RUSSIAN FEDERATION
MINISTRY OF TRANSPORT OF RUSSIAN FEDERATION
FEDERAL AIR TRANSPORT AGENCY
AIRWORTHINESS DIRECTIVE

No. 2022-AHCAT, AHCAT-K-02

Applicability – ANSAT helicopters (ANSAT, ANSAT-GC models), ANSAT-K helicopters (ANSAT-K model) and their modifications

TECHNICAL DECISION No. 3/144-2021-KB3
on continued airworthiness of ANSAT, ANSAT-K helicopters and their modifications
in connection with failure of the bearing 6-3056204 ETY100/3 of tail rotor sliding bar
Revision 2

List of parts and assemblies of tail rotor hub

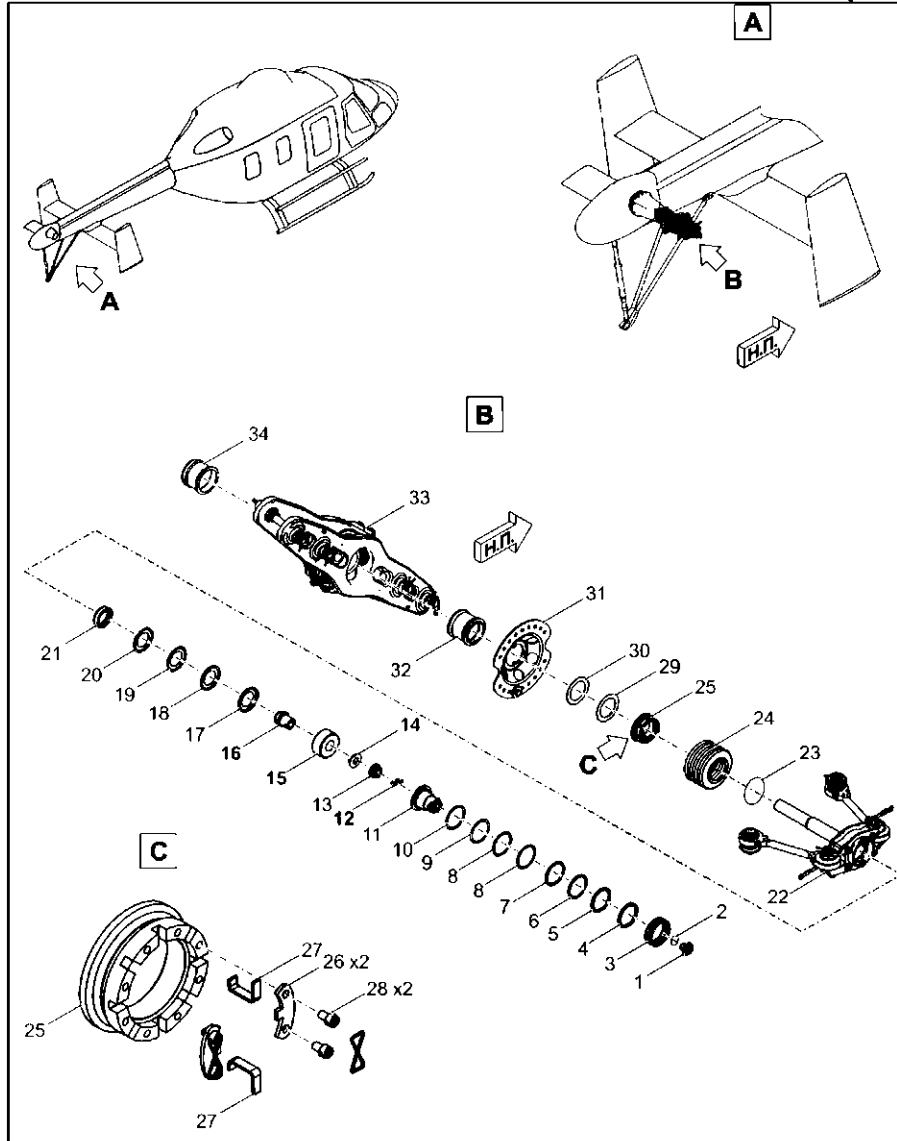
1. Operators of ANSAT helicopters (ANSAT, ANSAT-GC models), ANSAT-K helicopters (ANSAT-K model) and their modifications serial Nos. 33013, 33014, 33027...33135 to perform one-time replacement of sleeves 333.3500.0015 with serial numbers up to No. 2401 with new ones (pos. 16 in Appendix 1 to the Technical Decision of JSC "Kazan Helicopters" No. 3/144-2021-KB3 Revision 2 dated 17.01.2022), when performing regular scheduled work on the replacement of bearings 6-3056204 ETY100/3 (6-3056204Y ETY100/3) in accordance with the Airworthiness directive No. 2021-AHCAT, AHCAT-K-04 dated 21.10.2021 and Airworthiness directive

1. During the next works on replacement the bearing 6-3056204 ETY100/3 (6-3056204Y ETY100/3) in accordance with the task cards 064.20.00c, 064.20.00d of Maintenance manuals 338.0000.00PЭ, 343.0000.00PЭ of the ANSAT helicopter (ANSAT, ANSAT-GC models, respectively), in accordance with the task cards 065.20.00c, 065.20.00d of Maintenance manual 340.0000.00PЭ (for AHCAT-K helicopter), replace the sleeve 333.3500.0015 (pos. 16 in Appendix 1) with the new one. Replacement of the sleeve is carried out on one-time basis, the sleeve is provided by JSC “Kazan Helicopters” at the expense of its own funds upon customer’s request. The removed sleeves should be sent back to JSC “Kazan Helicopters”.

2. Sleeves 333.3500.0015 with serial numbers 2401 and further, provided by JSC "Kazan Helicopters" to operators as technical assistance within the frame of works under Airworthiness Directives No. 2021-AHCAT, AHCAT-K-04 dated 21.10.2021 and No. 2021-AHCAT-CK-05 dated 03.12.2021, are not subject to replacement.
